RE: Proposed Phase II Site Assessment Workplan
Union Pacific Motor Freight Facility
Oakland TOFC Railyard
1750 Ferro Street
Oakland, California

PROPOSED
PHASE II SITE ASSESSMENT
WORKPLAN

UNION PACIFIC RAILROAD
UPMF FACILITY
1750 Ferro Street
Oakland, California
USPCI Project No. 96281

| FIGURE 5 | | | |

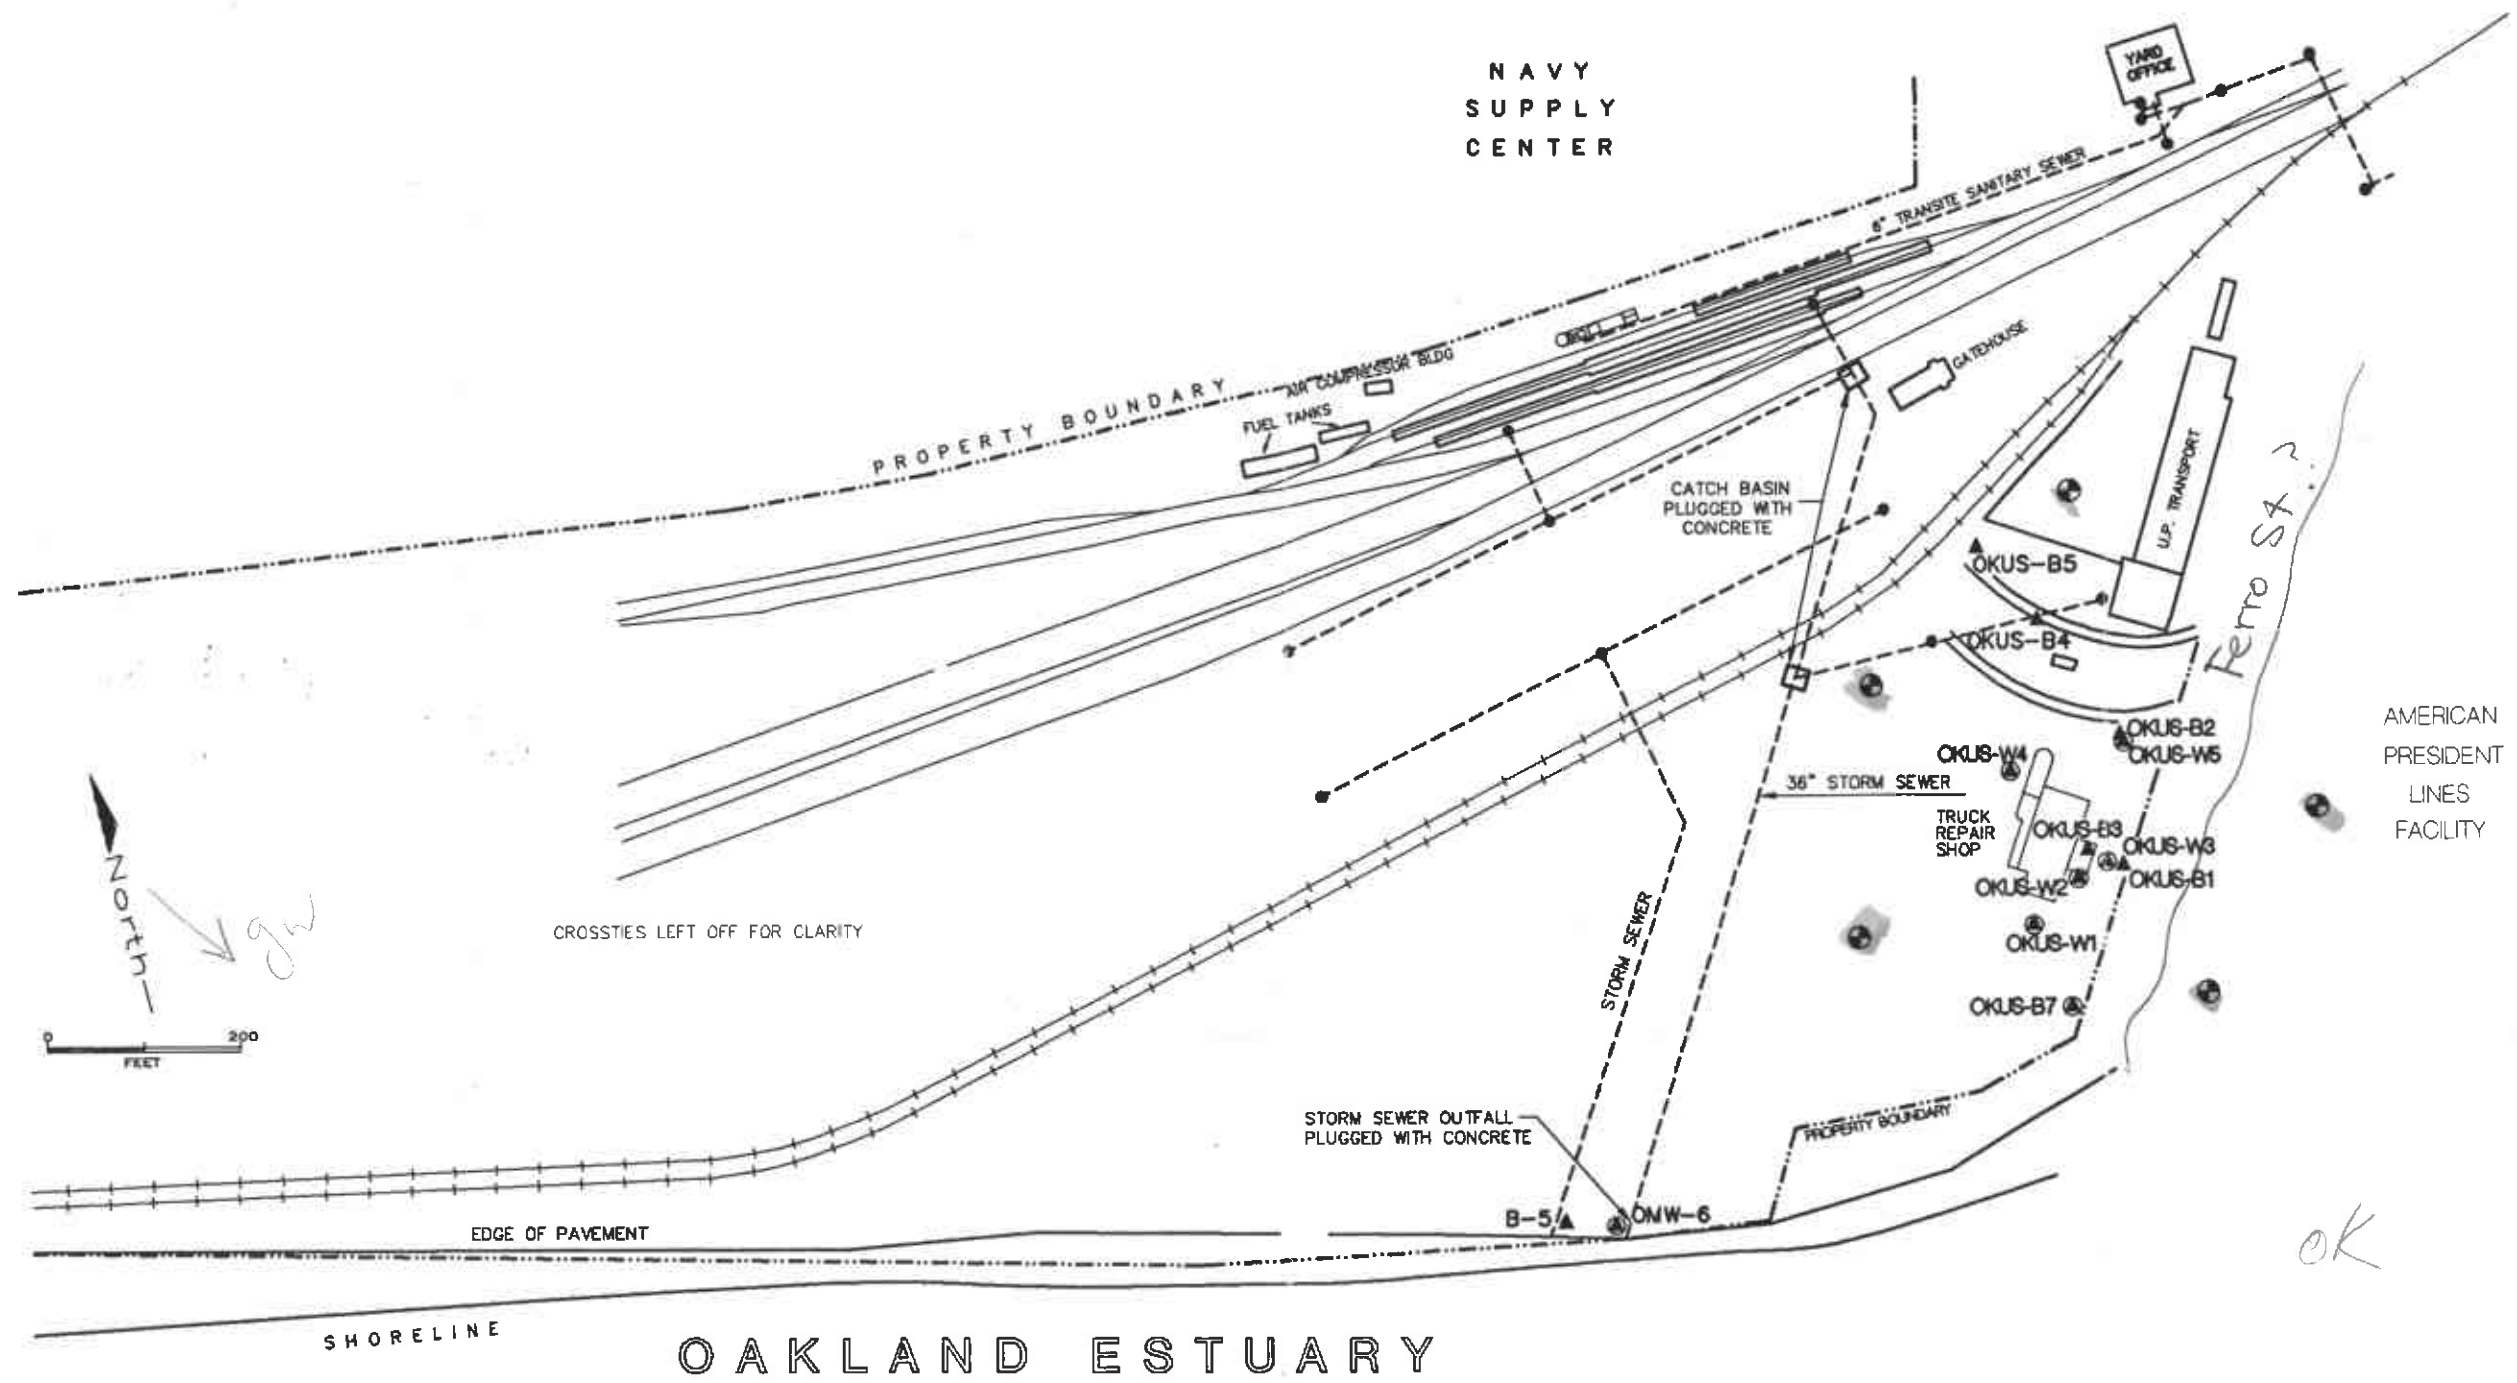
gradient from the estimated dissolved-phase plume near the former gasoline and diesel tank pit area (Figure 5). ✓
